ADDENDUM NO. 3

August 7, 2026

MERRILLVILLE HS CULINARY AND MEETING AREA RENOVATIONS AND MERRILLVILLE CSC CENTRAL OFFICE ADDITION AND RENOVATION PROJECT

This Addendum consists of pages ADD 3-1 through ADD 3-2 and attached Addendum No. 3 from Gibraltar Design dated August 6, 2026, and consisting of 5 pages, Specification Section 10 11 00 - Markerboards and Corkboards, Specification Section 28 13 00 - Access Control System, and 22 Drawings.

ELECTRIC CORD REEL DETAIL

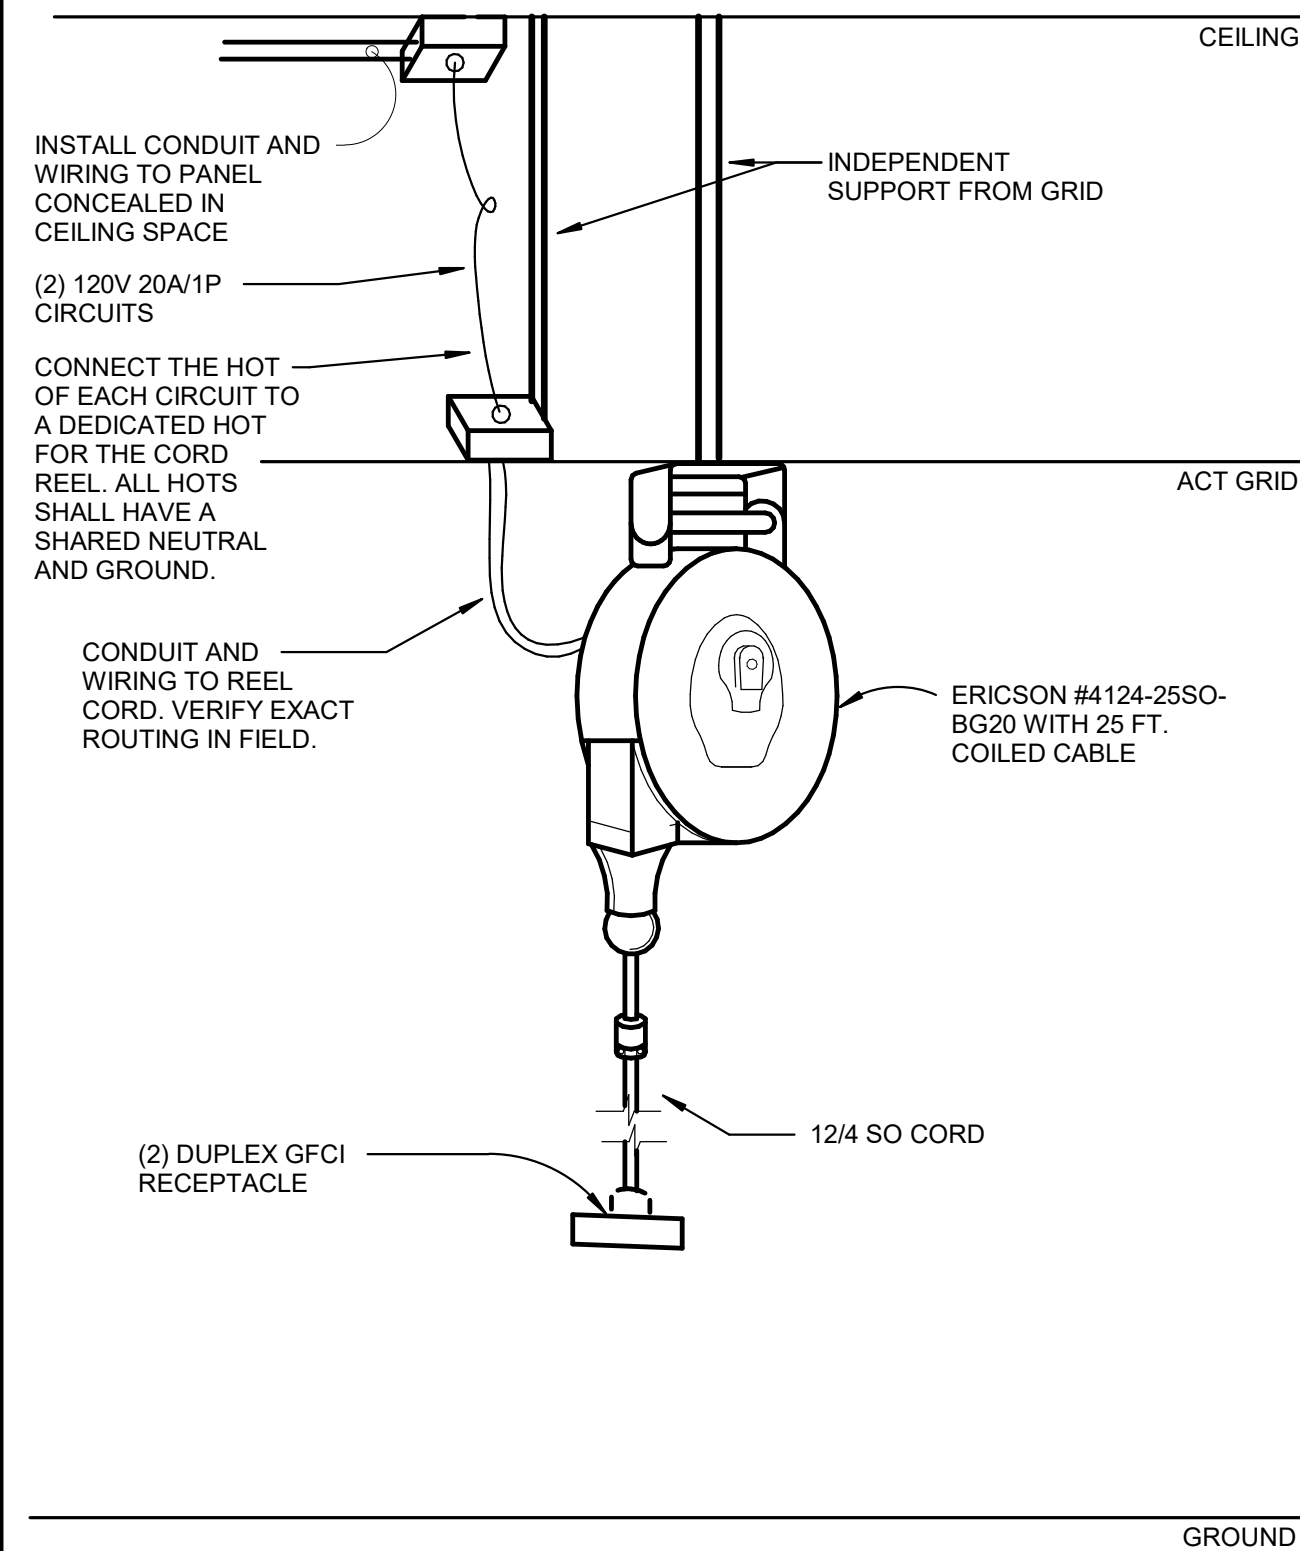
21. Sheet E-603

- A. Refer to revised, full-size drawing, included in this Addendum, for revisions.
 - 1. Revised electric cord reel detail

DRAWING
UNIT "T" TECHNOLOGY FIRST FLOOR PLAN

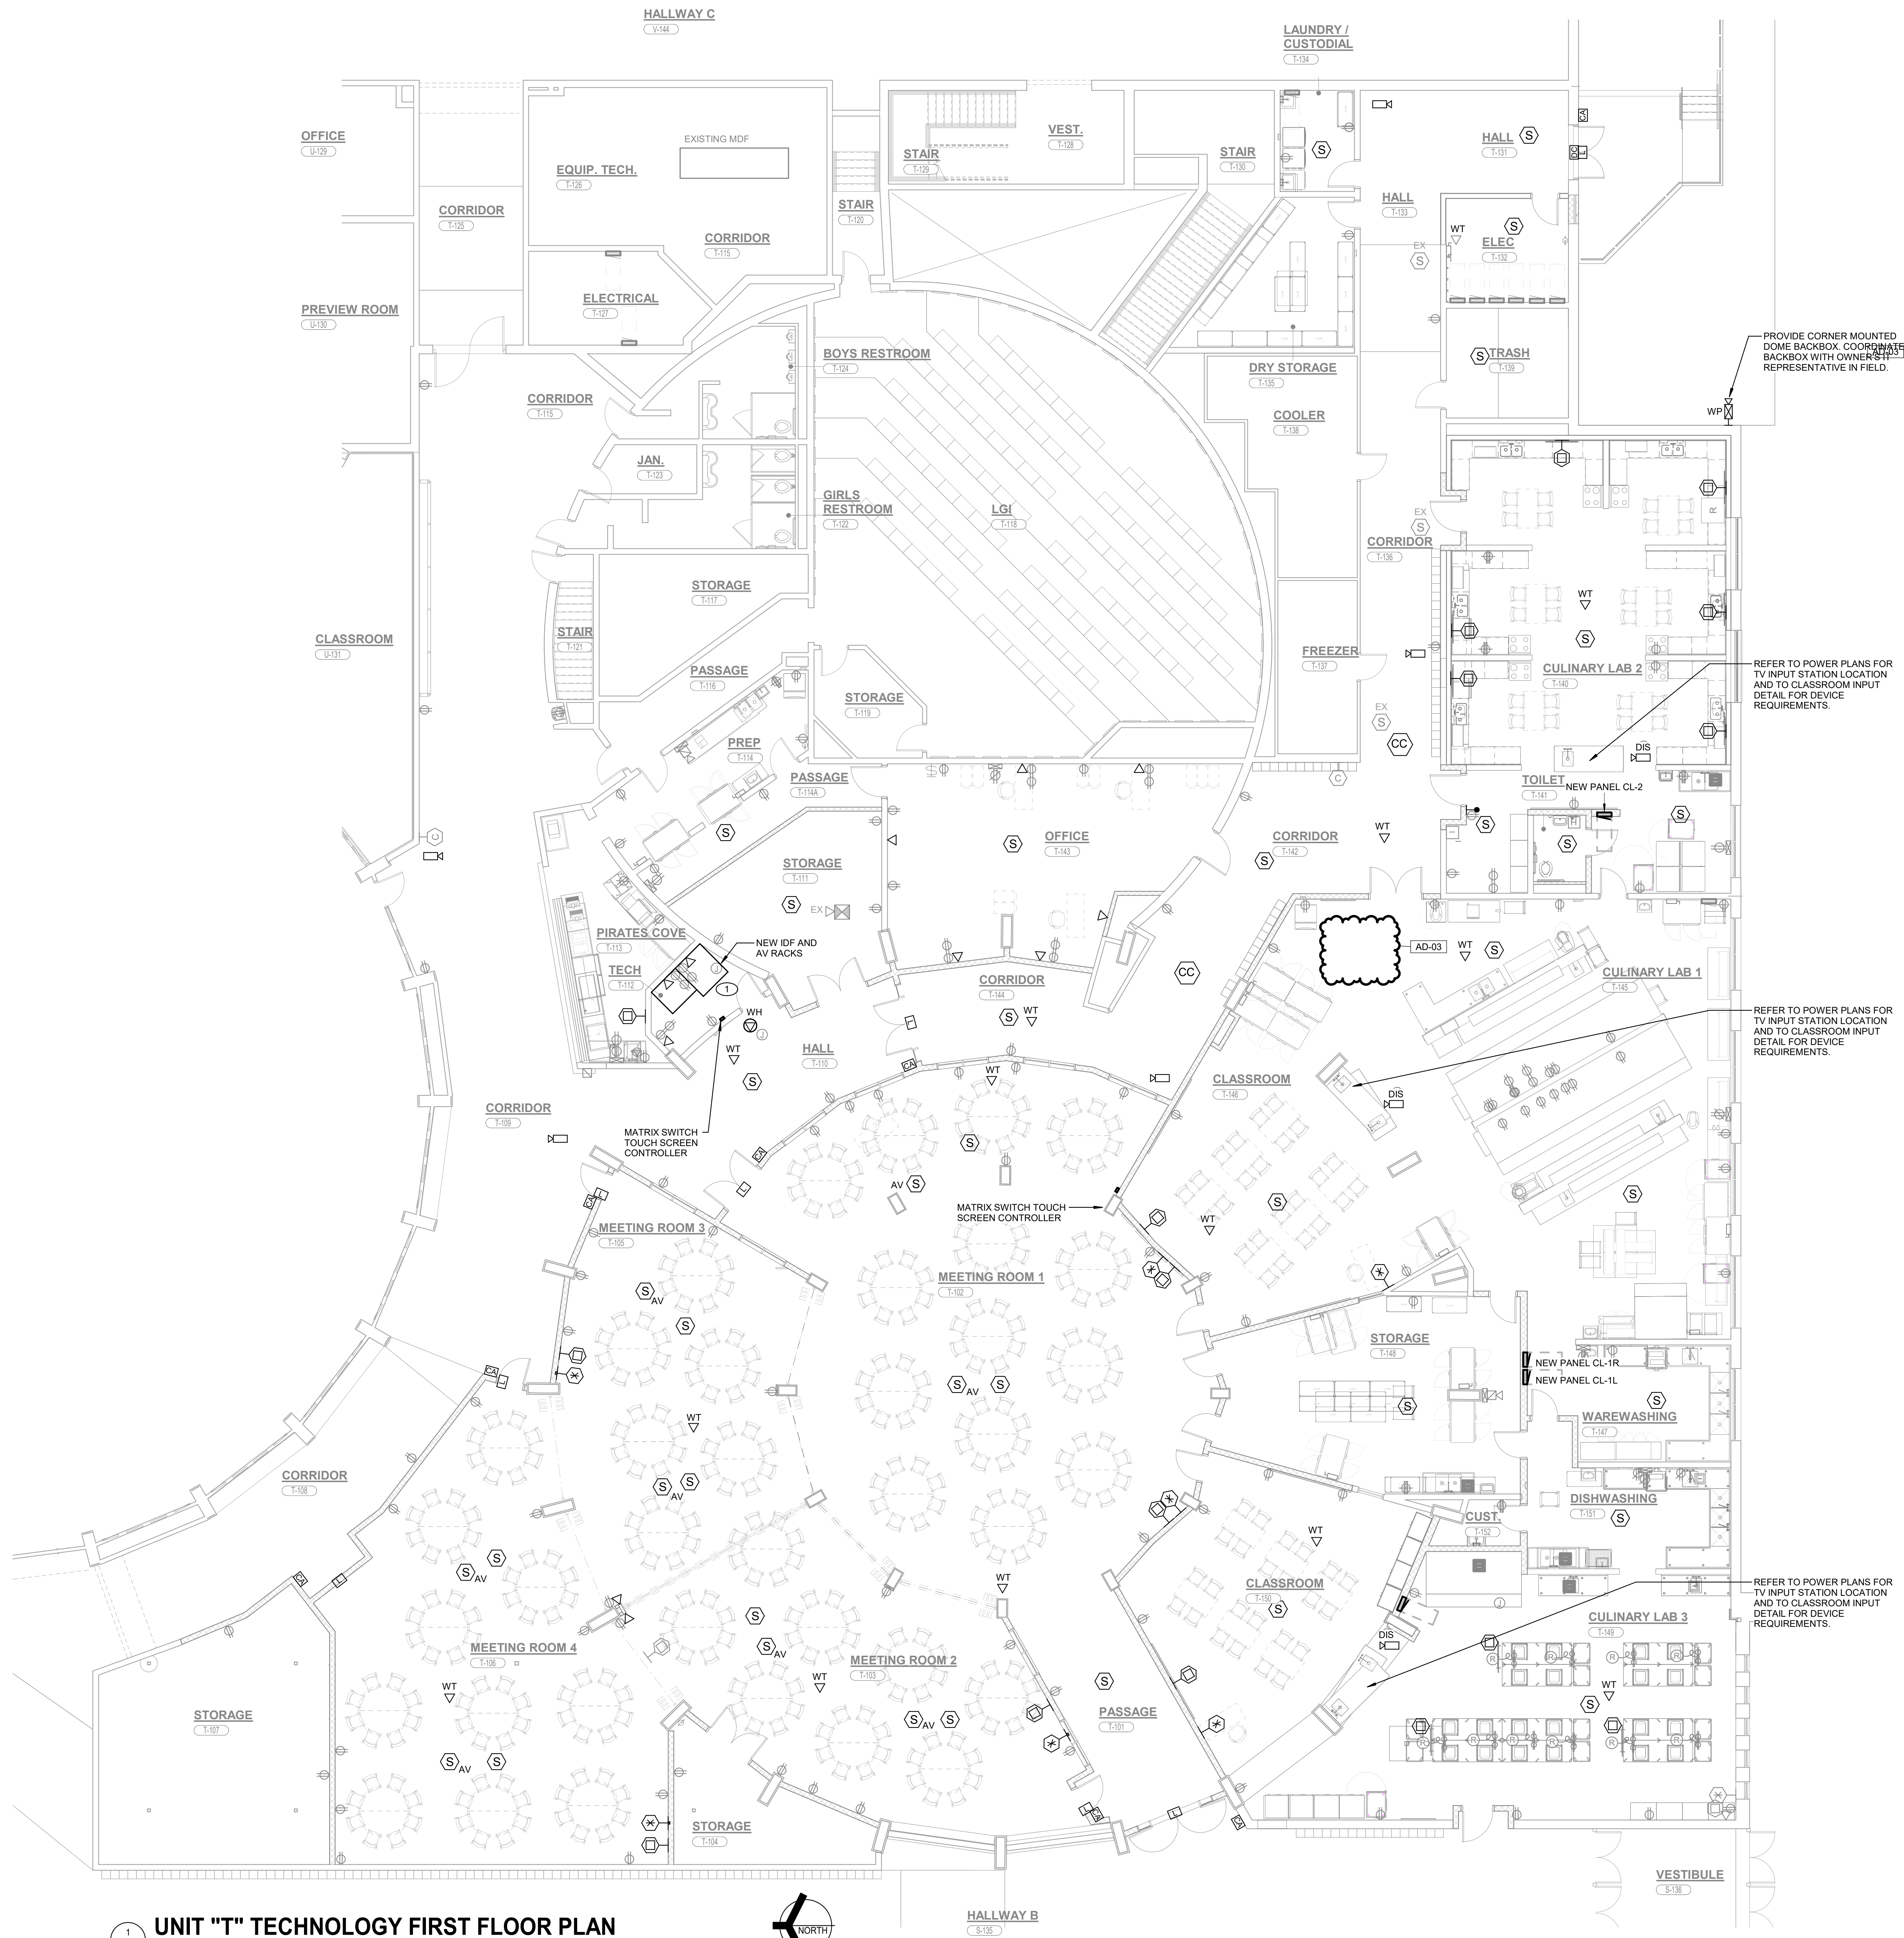
23. Sheet T-121

- A. Refer to revised, full-size drawing, included in this Addendum, for revisions.
 - 1. Added General Note #1 & 2
 - 2. Removed corridor clock from Culinary Lab #1

DRAWING TECHNOLOGY DETAILS & DIAGRAMS

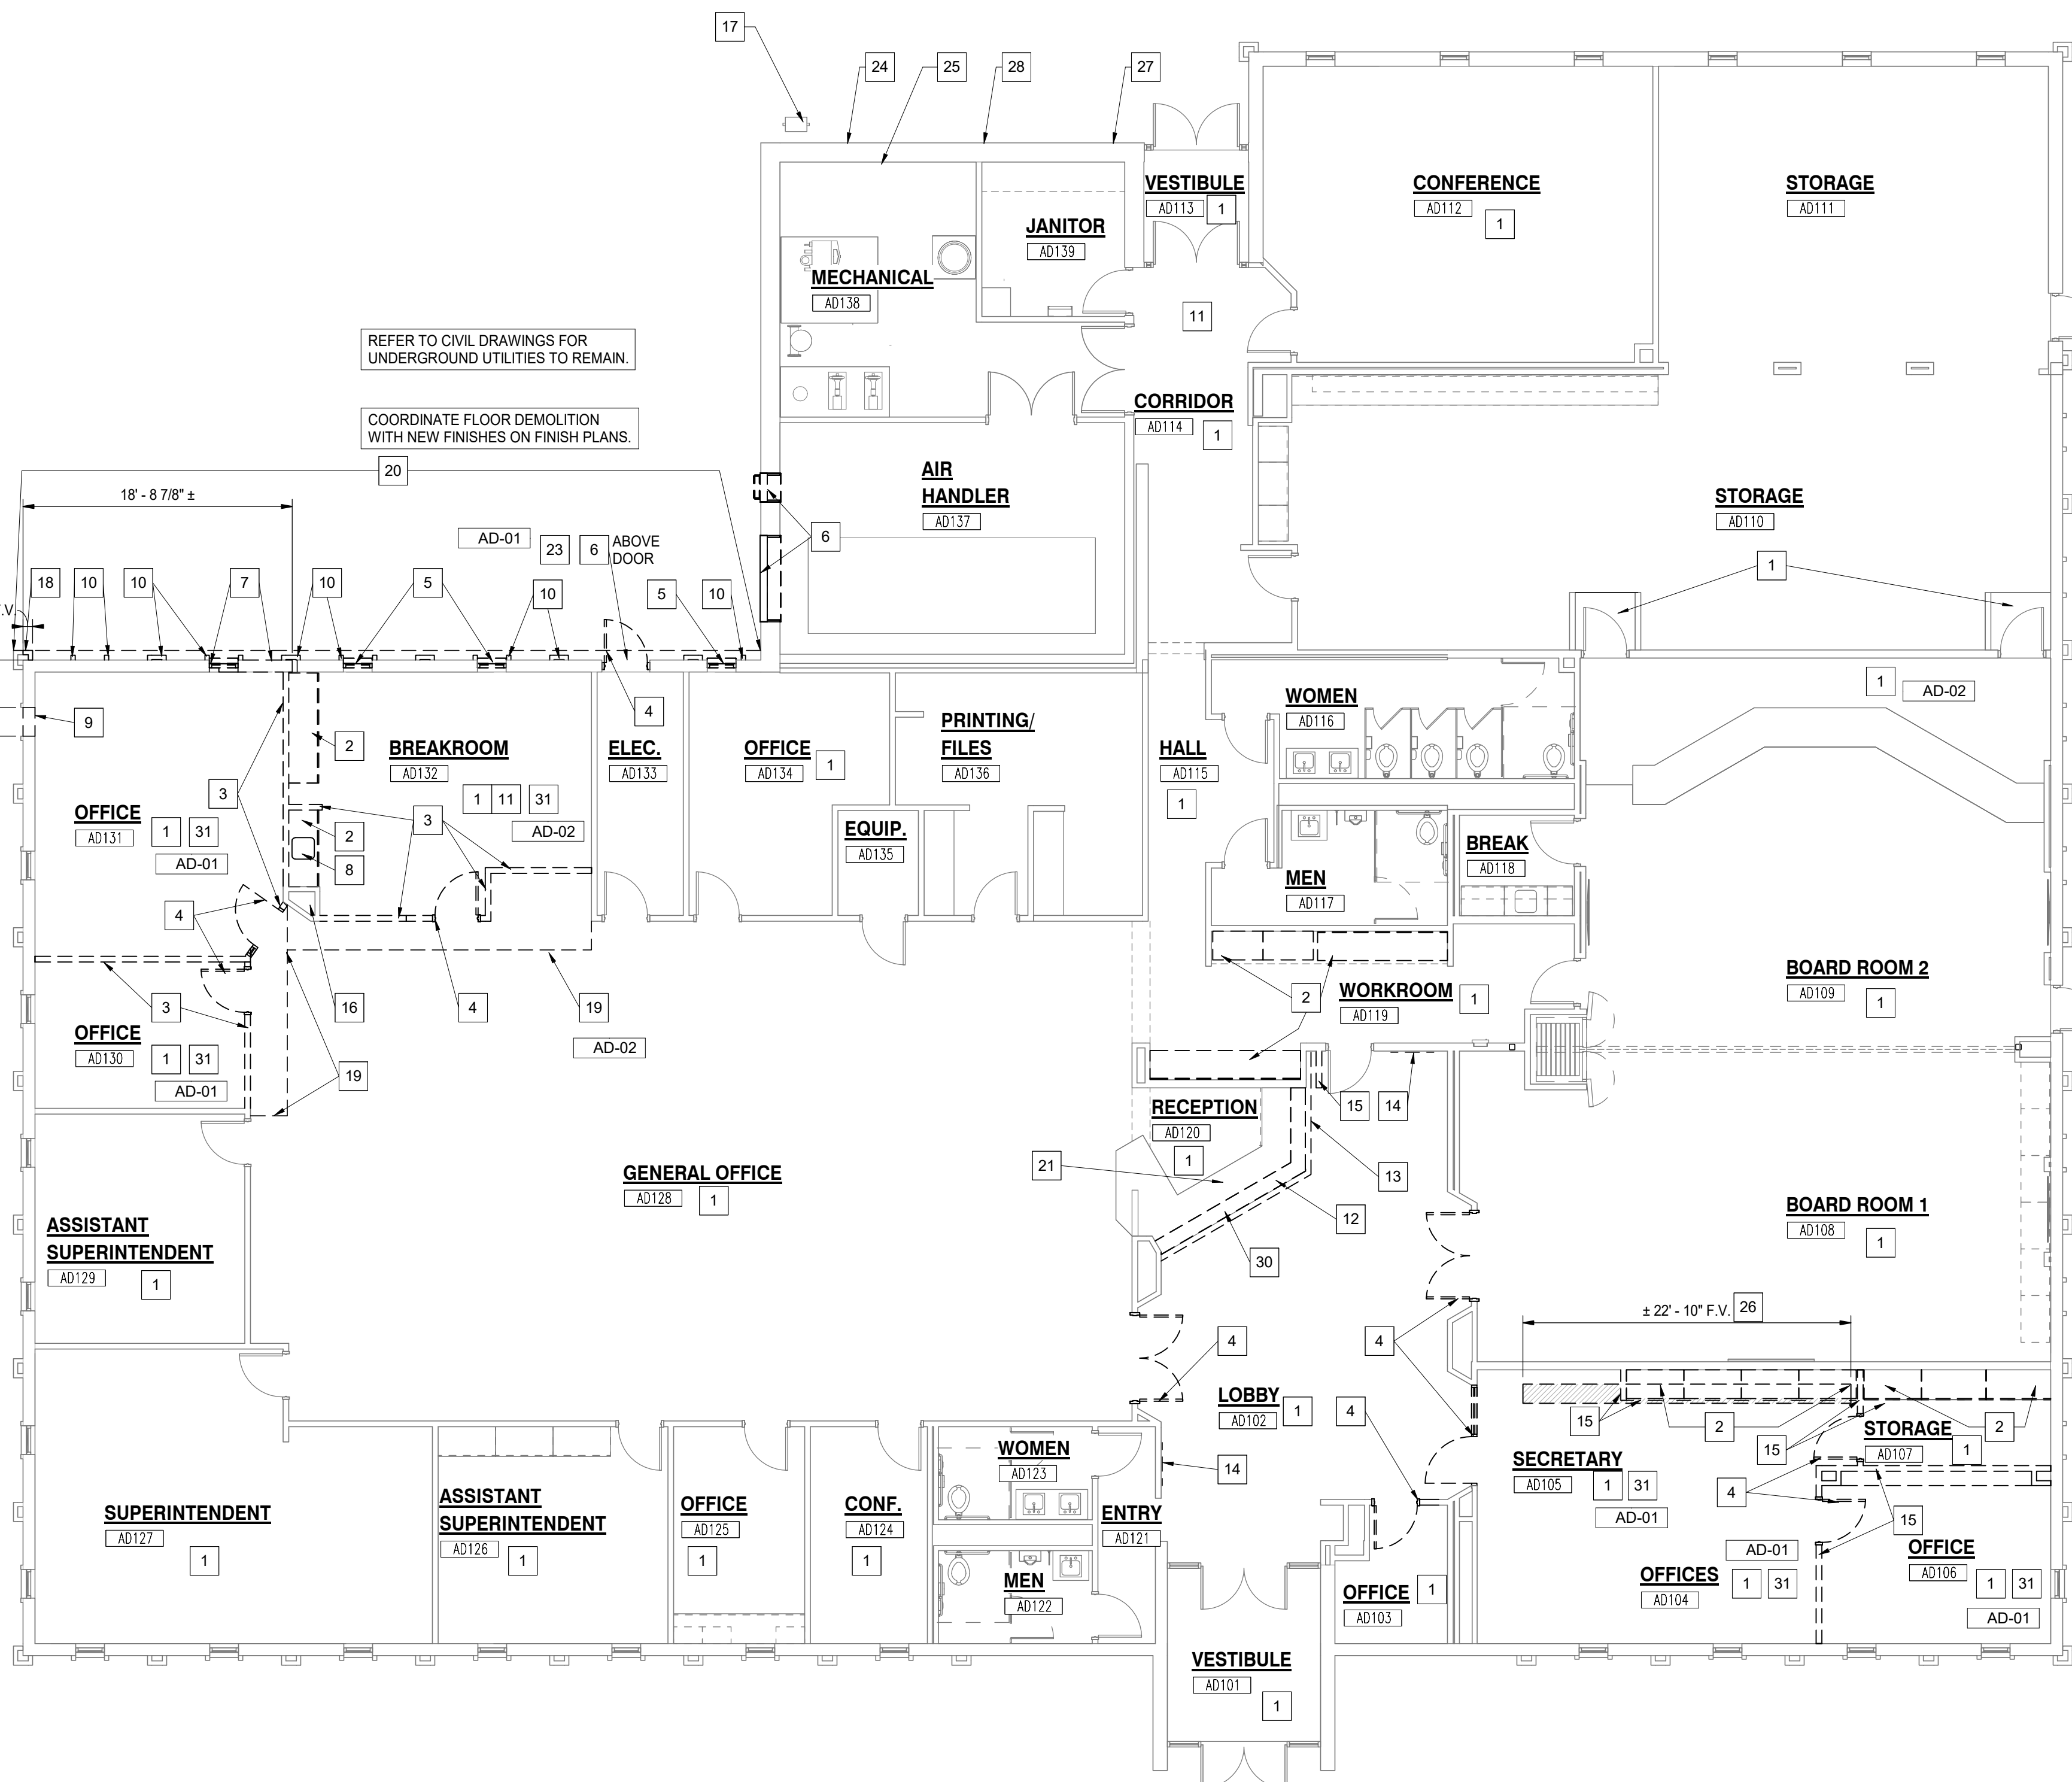
25. Sheet T-602

- A. Refer to revised, full-size drawing, included in this Addendum, for revisions.
 - 1. Added IDF Rack Layout Detail.
 - 2. Updated access control wiring diagram.
